## HISTORIC AND DESIGN REVIEW COMMISSION

**HDRC CASE NO:** 2019-553  
**COMMON NAME:** 204 HAYS  
**ADDRESS:** 728 CHESTNUT ST  
**LEGAL DESCRIPTION:** NCB 535 BLK 23 LOT 1 EXC NW 15.68FT TRI  
**ZONING:** D  
**CITY COUNCIL DIST.:** 2  
**APPLICANT:** Adam Gates/Adam Word Gates - Architect  
**OWNER:** Stuart Allen/ALLEN STUART  
**TYPE OF WORK:** Construction of three, 3-story residential structures  
**APPLICATION RECEIVED:** September 13, 2019 (Postponed by Applicant)  
**CASE MANAGER:** Edward Hall

### REQUEST:

# HAYS STREET RESIDENCES

SITE PLAN  
1" = 10'

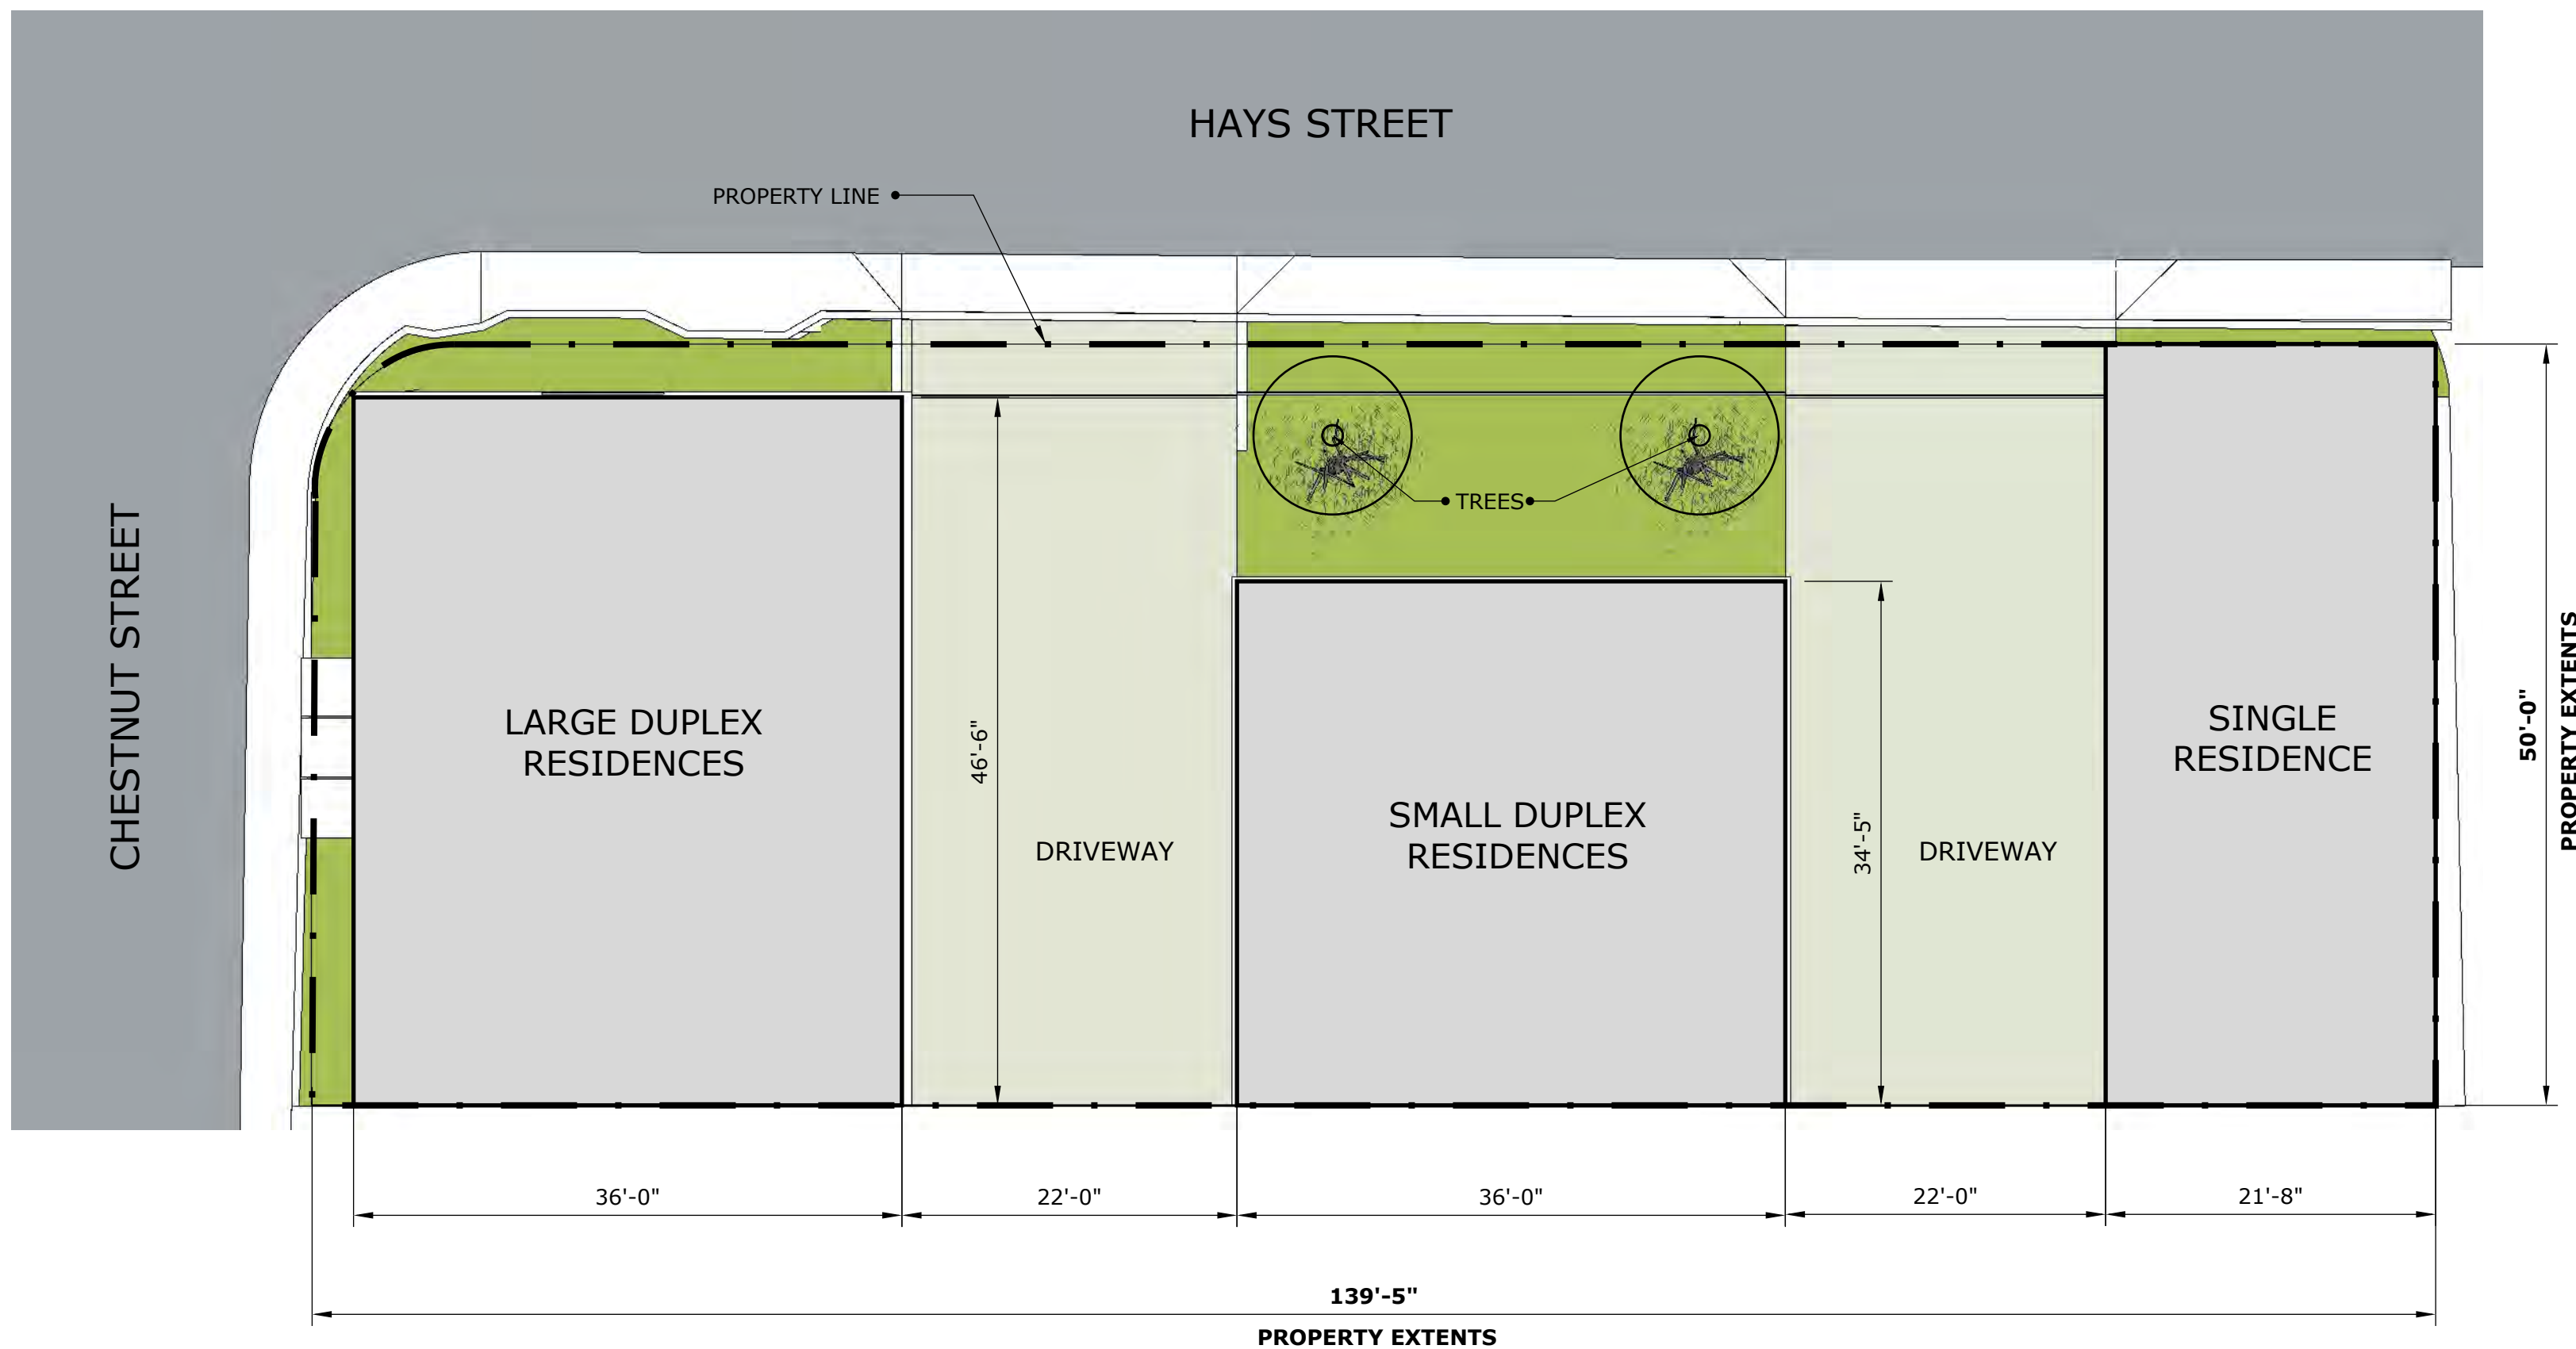
- e. SIDEWALK & SETBACK WIDTH – The Downtown Design Guide requires that a minimum of a seventy-two (72) inch sidewalk be provided, and that a continuous landscaped and hardscaped area should be provided adjacent to the curb on predominantly non-commercial streets. The applicant has provided the landscaped and hardscaped area. Staff finds that the applicant should match the existing sidewalks found on Hays and Chestnut.

- f. LANDSCAPE & HARDSCAPE – The applicant has noted the installation of a parkway along the curb, as noted in finding e and has noted in the installation of street trees, consistent with the Downtown Design Guide. Additionally, the applicant has provided detailed landscaping plan noting landscaping materials and their planned locations.

- g. PARKING & ACCESS – The Downtown Design Guide notes that parking should be integrated into the project that they serve. The Downtown Design Guide also notes that with the exception of the minimum ground-level frontage required to access parking and loading areas, no parking or loading should be visible on the ground floor of any building façade that faces a street. The applicant has proposed parking to be located on the ground floor of one unit, and between the proposed duplex structures. Generally, staff finds the location of the proposed parking to be appropriate as it is between structures, and will be screened from the right of way at Hays and Chestnut.

Staff recommends conceptual approval based on findings a through n with the following stipulations:

BIG DUPLEX - WEST ELEVATION

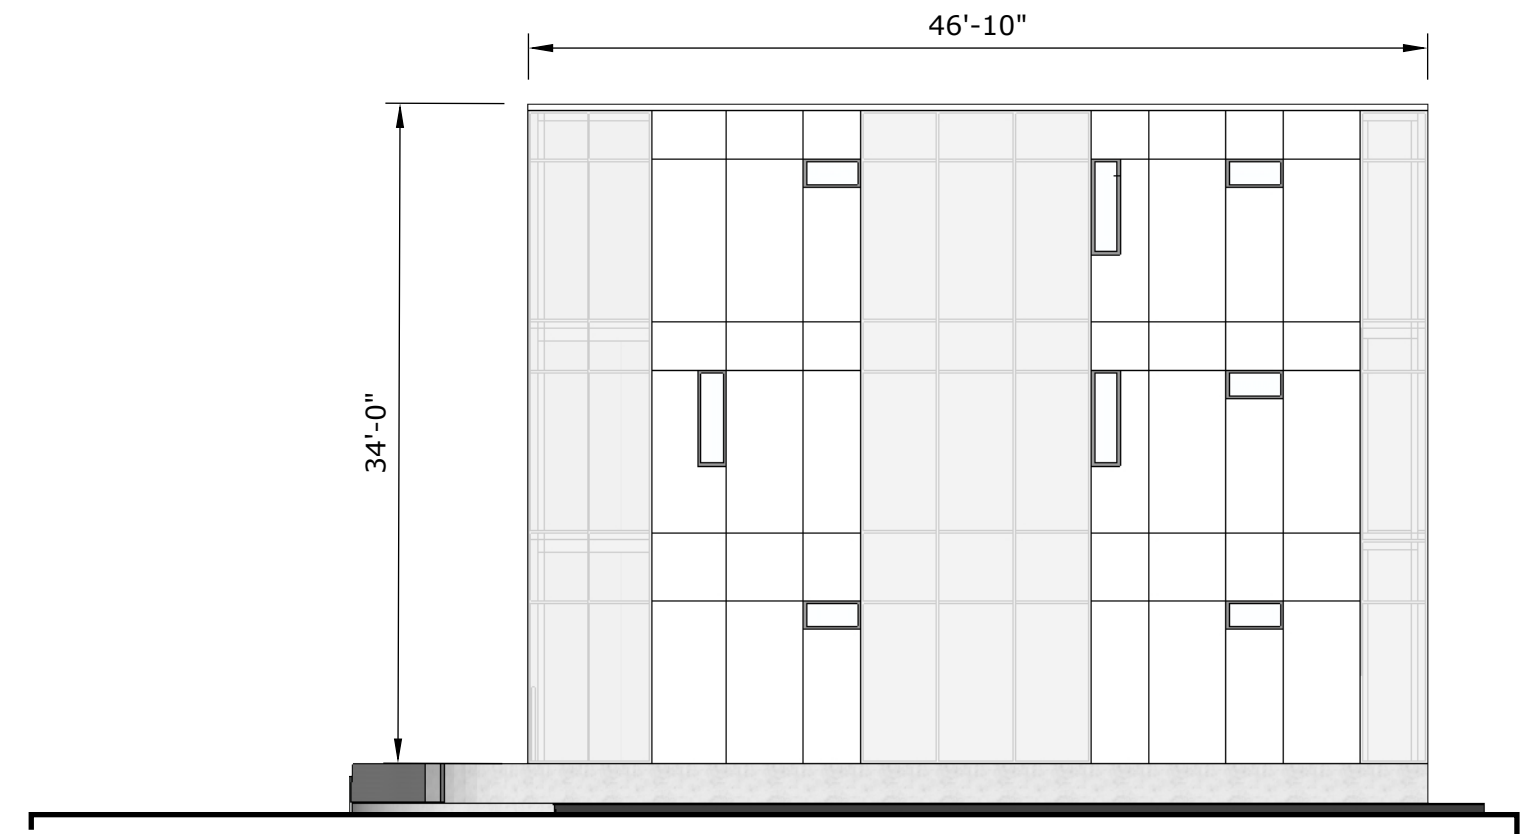
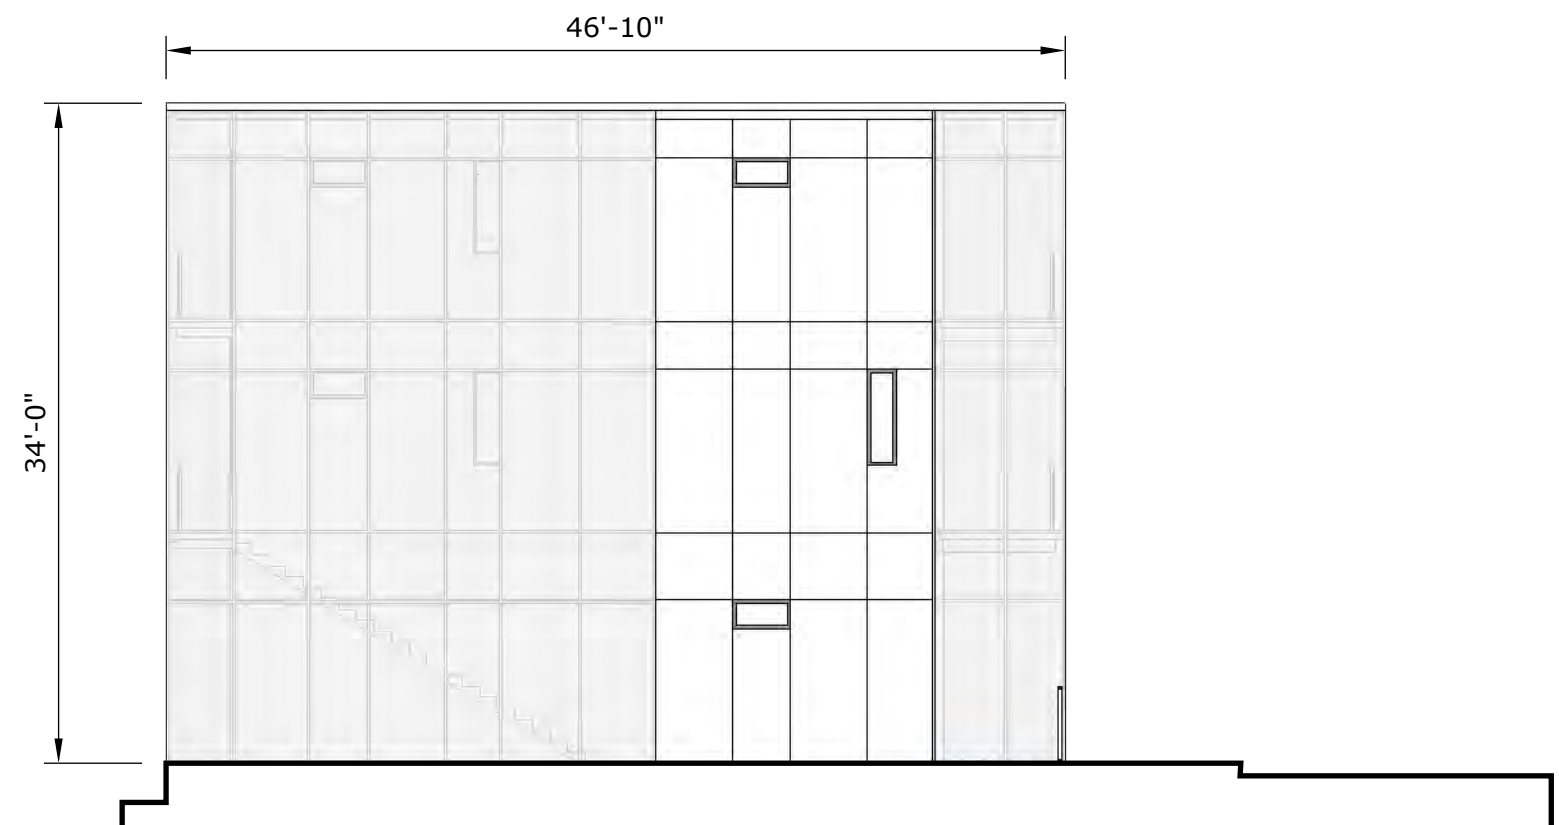
1  
AMG: DEVISE WEST ELEVATION AND SETBACKS,
